Cover Letter – FMS2

Machine Sensor Art No 584 91 89 05

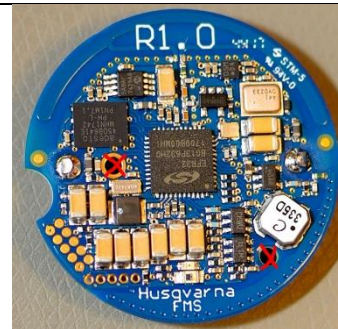
HW - revision	Comments
P1.2 A Prototype, not sold	PCBA used during certification
P1.2 B Prototype, not sold	Updated SoC with more RAM compared to P1.2 A. PCBA used during certification
R1.0 A Released	Identical to P1.2 B except: Color on PCB is blue. Some via holes are not covered by coating.
R1.1 A Released	Identical to P1.2 B except for the color on the PCB that is blue instead of green
R1.2 A Released	Identical to R1.1 but the two bigger holes on the PCB are covered to facilitate automatic machine coating of the board. See red X on photo.
